ALERT SERVICE BULLETIN

204B-17-73  
3 March 2017

**MODEL AFFECTED:** 204B

**SUBJECT:** MAGNETIC BRAKE ASSEMBLY 204-001-376-003,  
INSPECTION AND REPAIR OF.

Figure 1. Magnetic brake assembly.

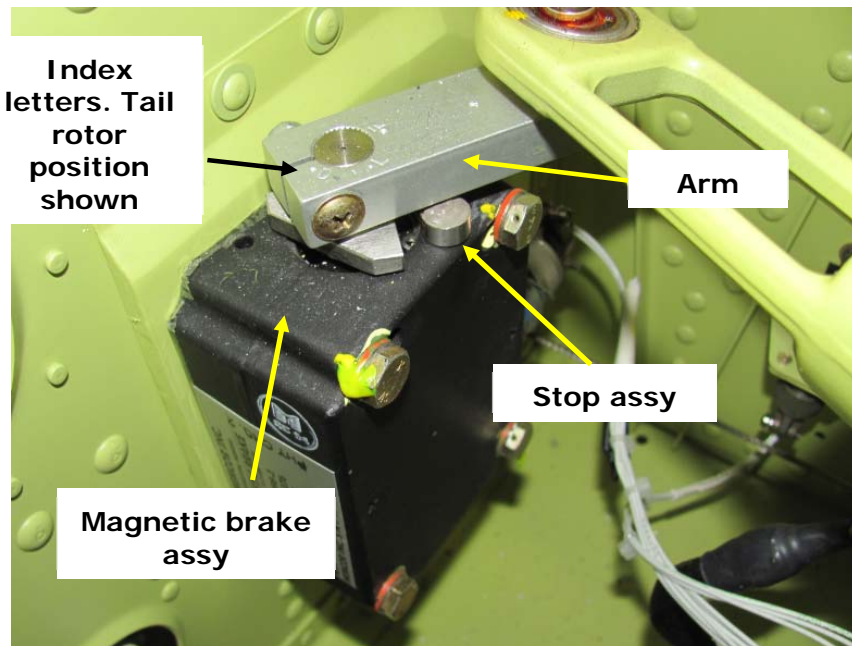
1. Prepare the helicopter for maintenance.
2. Gain access to the cyclic and tail rotor magnetic brake assembly (BHT-204B-M&O).
3. Perform a detailed visual inspection of the stop assemblies (Figures 1 and 2). Figures 3 and 4 show a stop assembly found disbonded.

Figure 3. Stop assembly with disbonded shaft.

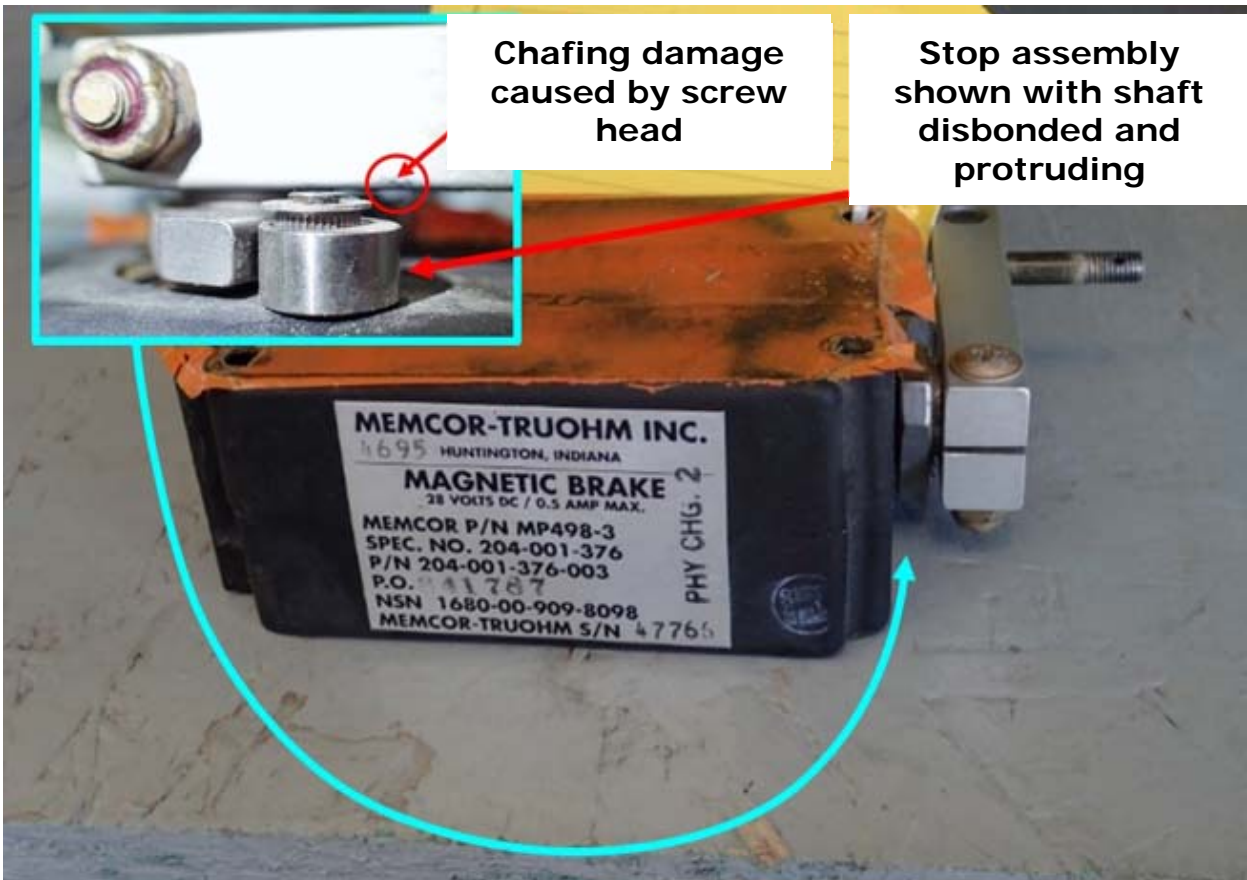
4. By hand, pull on the stop assembly to verify if the stop shaft is disbonded from the housing assembly.
5. If the shaft shows evidence of disbonding, inspect the lower side of the arm for possible chafing damage and accomplish Part II. The maximum allowable mechanical damage is 0.030 inch. (0.762 mm).
